Refusal of Planning Permission

Reference: H23/0333/94 Received:05-APR-94 Type:FULL

Description: Proposed 3 bed bungalow and single garage

Location : Adj. 17 Chapelgate Whaplode Drove
Spalding Lincs

PLANNING APPLICATION No.H23/0333/94

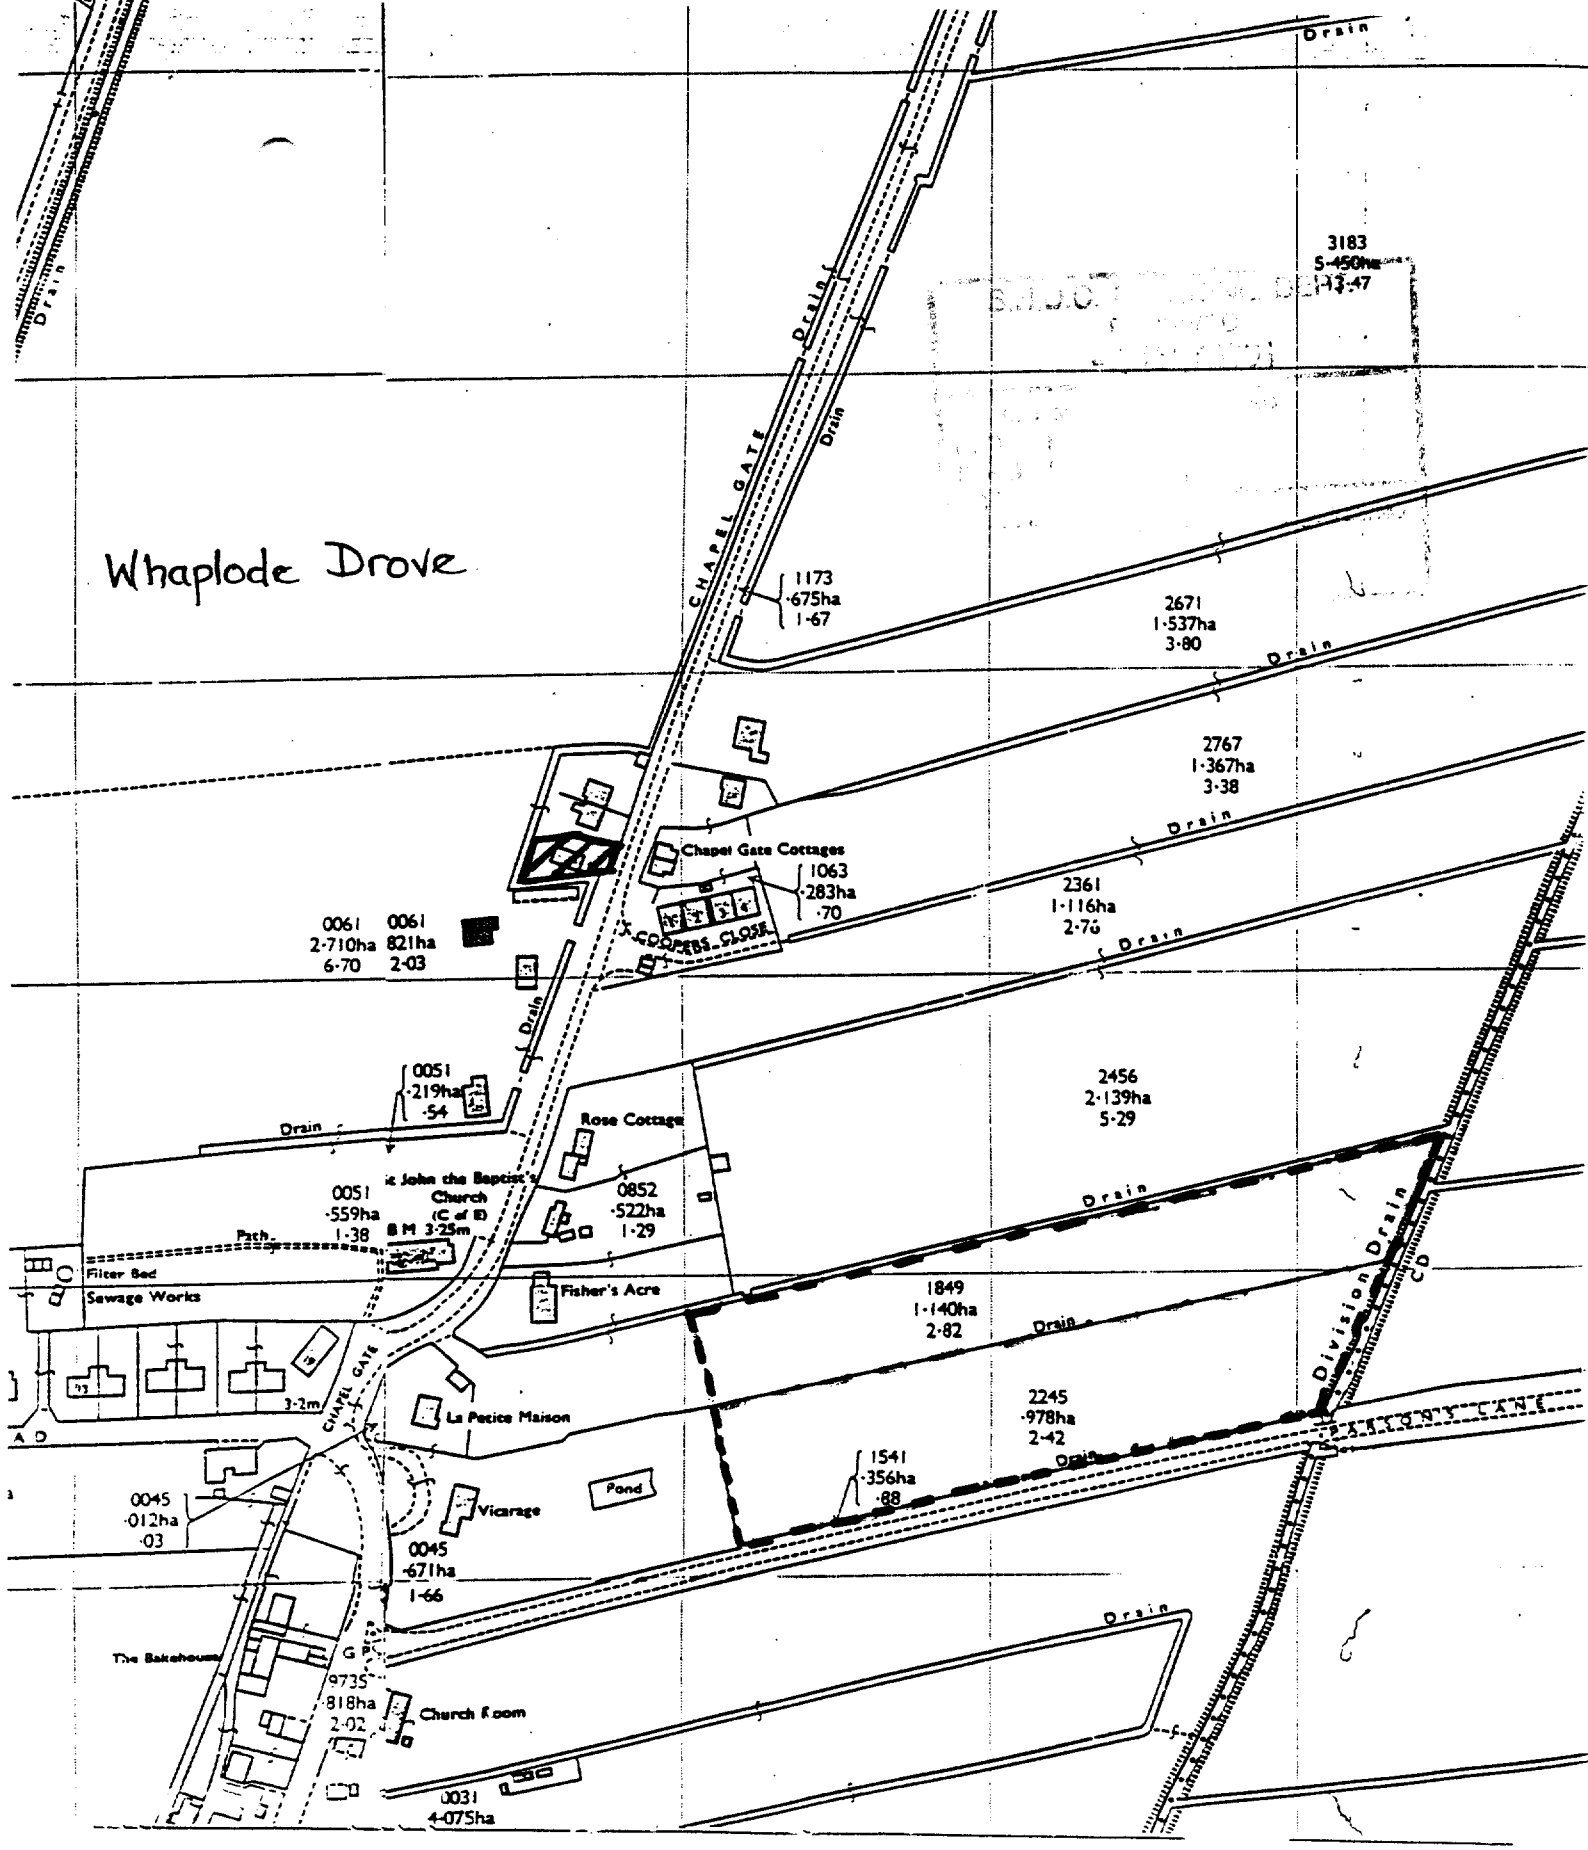
The application site lies within 250m of the former landfill off Parson's Lane, Whaplode Drove, Spalding.

The site was notified to this office by your Authority,however, details of the types and depths of waste deposited, the site's period of use and the exact boundary of the waste are not available.

The Authority is not aware of any landfill gas related problems at the application site or in the surrounding area. It would seem reasonable to suggest therefore, that the development might suffer no further hazard from landfill gas than may already exist.

DRAWING No.
94-816

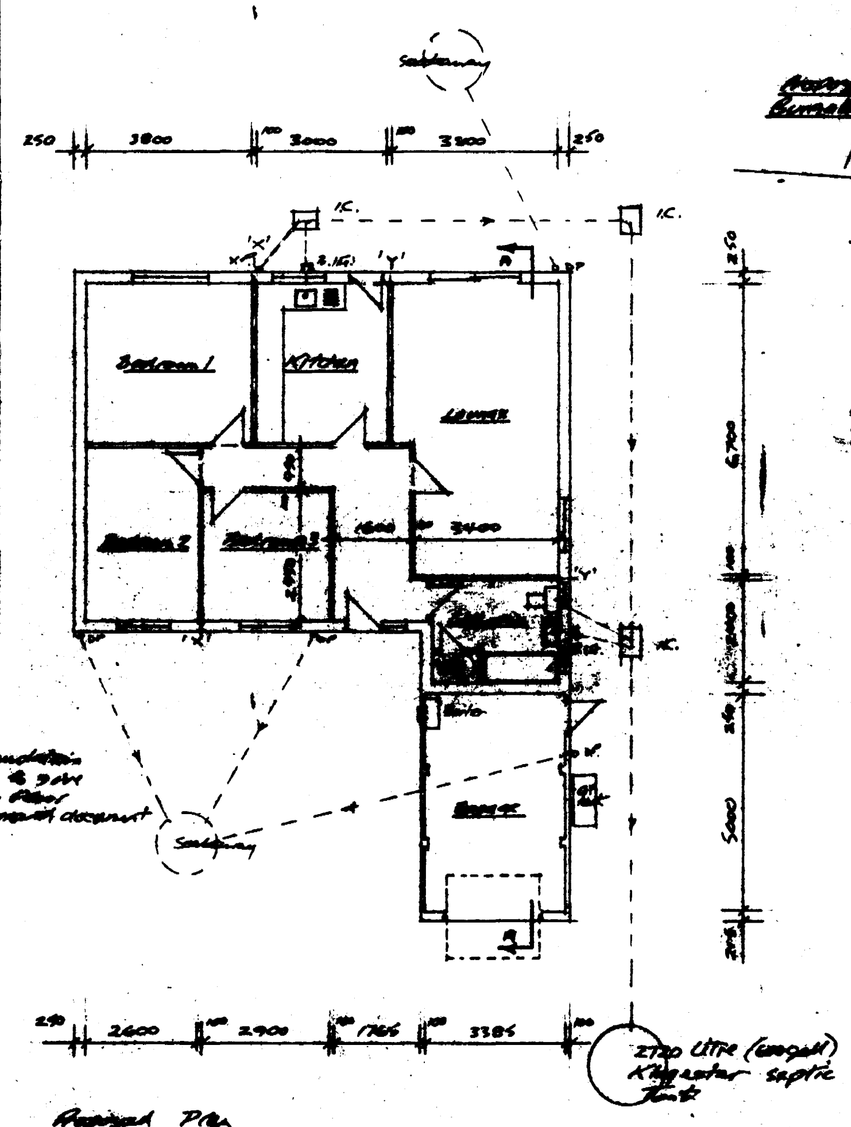
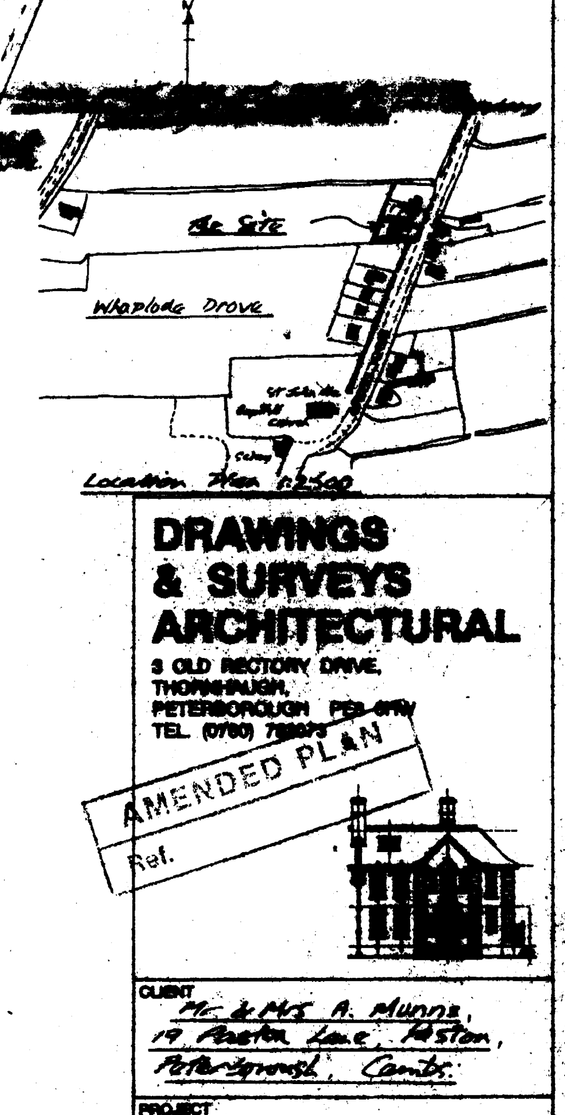
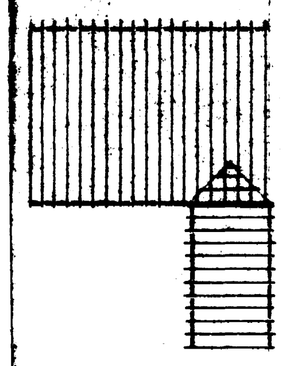
Firstly, I would be pleased if you could submit four amended 1:500 site plans clearly showing the position of the proposed access, plus surfacing.

Further, it is noted that there are presently some trees upon the site, including a Silver Birch along the frontage. These should be retained as far as possible, and included as part of the landscaping scheme (some additional planting may be necessary).

DRIVE & LANDSCAPE DETAILS.
